World Forum for Harmonization of Vehicle Regulations

Working Party on Passive Safety

Forty-seventh session

Regulation No. 94 (Frontal collision)**Proposal for 02 series of amendments to Regulation No. 94****Submitted by the expert from France***

Figure 1: Measurement of Vb, V1, V2, V3

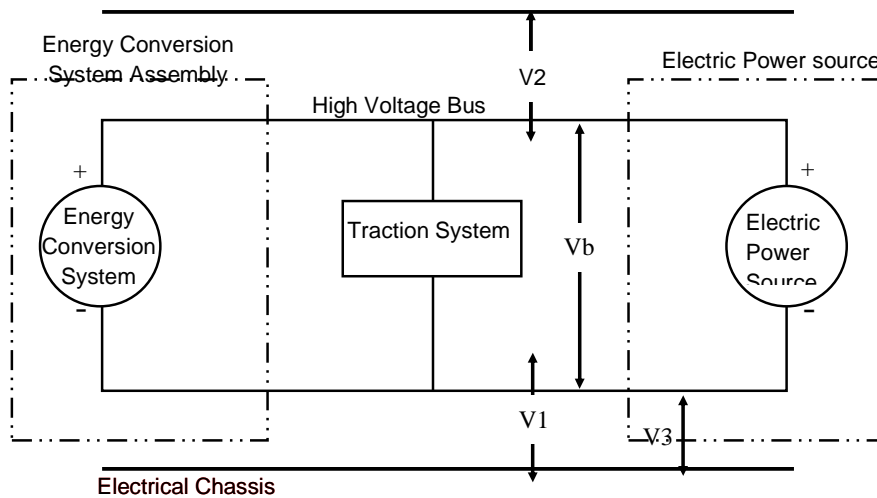
Before the vehicle crash test, measure and record the high voltage bus voltage (Vb) (see figure 1) and confirm that it is within the operating voltage of the vehicle as defined by the manufacturer.

After the crash test, determine the high voltage bus voltages (Vb, V1, V2) (see figure 1). If the RESS has exposed conductive parts, measure the voltage V3 between any exposed conductive parts of it and the electrical chassis.

Figure 2: Measurement of high voltage bus energy

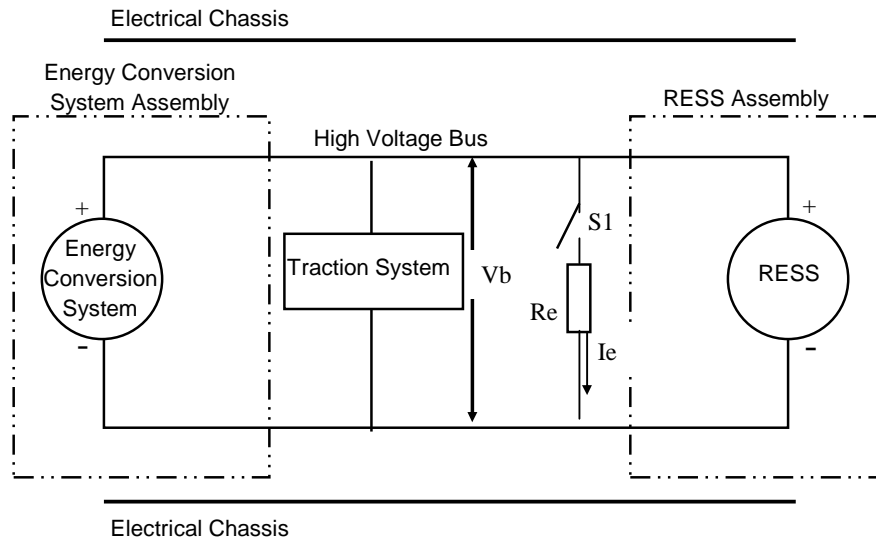
Prior to the impact a switch S1 and a known discharge resistor Re is installed according to figure 2. [At 5 seconds] after the impact the switch S1 is closed while the voltage Vb and the current Ie is measured and recorded. The product of the voltage Vb and the current Ie is integrated over the period of time starting from the moment when the switch S1 is closed (tc) until the voltage Vb falls below the high voltage threshold of 30 V AC or 60 V DC (th), resulting in the total energy (TE) in joules.

Figure 3: Measurement of V1'

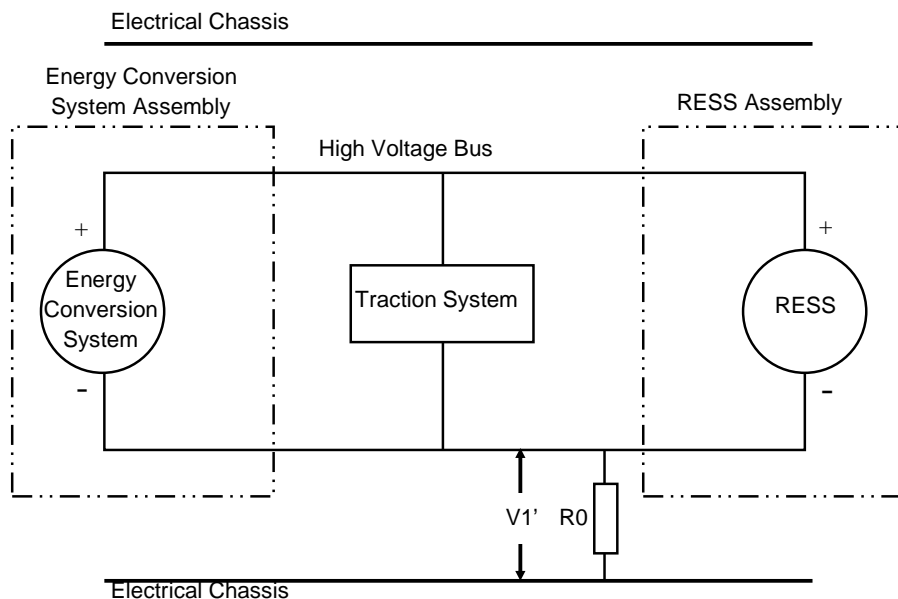
If V1 is greater than or equal to V2, insert a standard known resistance (Ro) between the negative side of the high voltage bus and the electrical chassis. With Ro installed, measure the voltage (V1') between the negative side of the high voltage bus and the vehicle electrical chassis (see figure 3). Calculate the isolation resistance (Ri) according to the formula shown. Divide this electrical isolation resistance value (in Ω) by the working voltage of the high voltage bus (in volts).

Figure 4: Measurement of V_2'

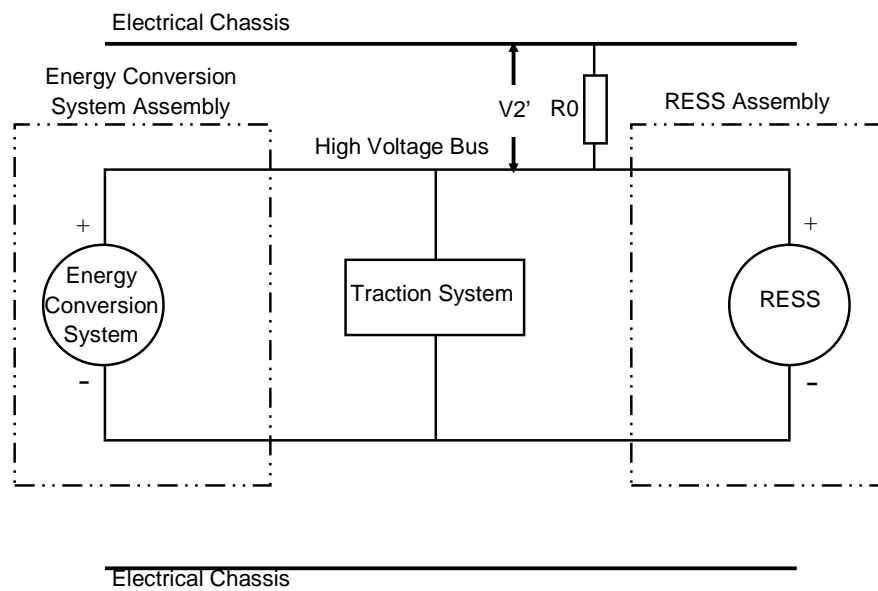
If V_2 is greater than V_1 , insert a standard known resistance (R_0) between the positive side of the high voltage bus and the electrical chassis. With R_0 installed, measure the voltage (V_2') between the positive side of the high voltage bus and the electrical chassis (see figure 4).

Calculate the isolation resistance (R_i) according to the formula shown. Divide this electrical isolation value (in Ω) by the working voltage of the high voltage bus (in volts).

Figure 1: Jointed test finger

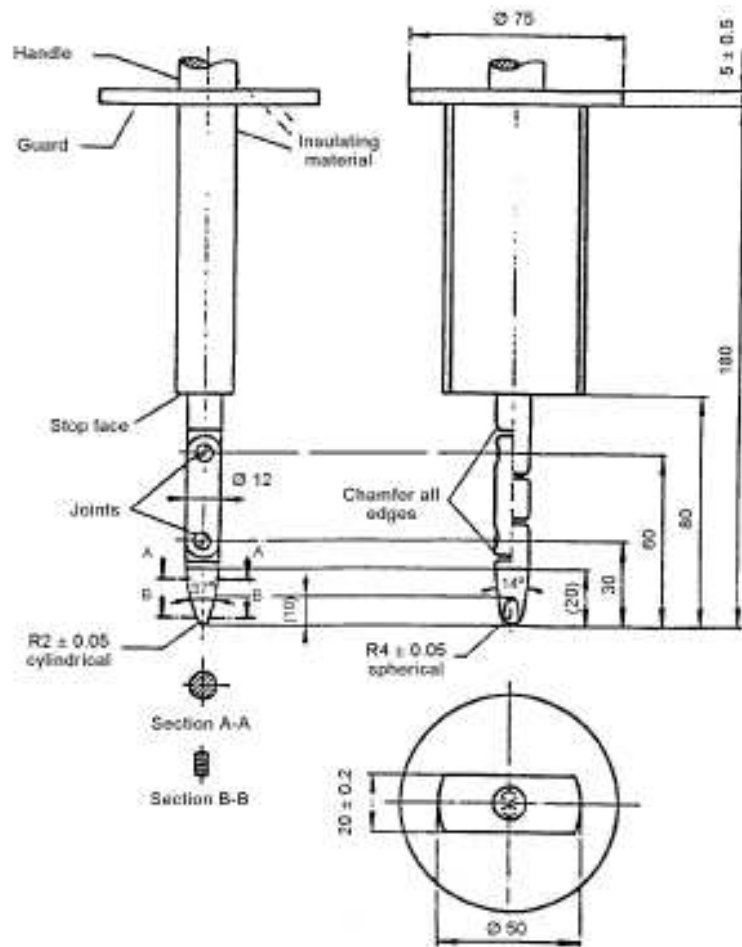
In the case of the test for IPXXB, the jointed test finger may penetrate to its 80 mm length, but the stop face (diameter 50 mm x 20 mm) shall not pass through the opening. Starting from the straight position, both joints of the test finger shall be successively bent through an angle of up to 90 degree with respect to the axis of the adjoining section of the finger and shall be placed in every possible position.

Both joints shall permit movement in the same plane and the same direction through an angle of 90° with a 0 to +10° tolerance.”
